Service Bulletin on Gorham Gravity Storm

RE: Modification to Shock Swivel Block Assembly

TO: All Gorham Gravity Storm Owners/Operators RE: Modification to Winch Drum Shaft w/ropes

TO: All Gorham Gravity Storm Owners/Operators RE: Modification to rope attachment to winch drum.

Picture A

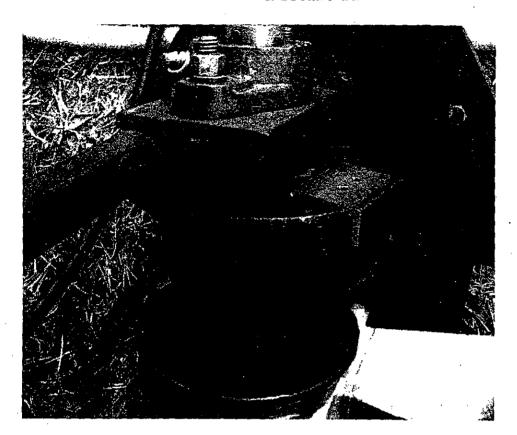
Knots in the tail end of the rope are no longer acceptable. You must retrofit your winch drum to the U-bolt style clamps. To complete this process we provide you with a jig tool, U-bolts w/ lock-washers & nuts, and instructional pictures. Follow these simple steps:

- 1. Until knot in rope and remove it from drum.
- 2. Rotate winch drums until the thru-hole is to an accessible side of the bearing tower.
- 3. Remove entire winch system from base by removing the (4) 3/8" bolts.
- 4. Place the jig directly in line with the hole on the outer edge of drum and tighten bolt to hold in place. (Pic. A)
- 5. Drill 3/16" pilot holes. (Pic. B)
- 6. Remove jig. Oversize 3/16" hole to 9/32".
- 7. Install U-bolts with U on outside of drum, lock-washers and nuts on inside. Just start the nuts DO NOT TIGHTEN.
- 8. Replace winch system to base with (4) 3/8" bolts.
- 9. Thread rope from inside of drum push out thru-hole, straight up through Ubolt to edge of drum. Tighten U-bolt snugly (7.5 lbs. of torque.) (Pic. C)
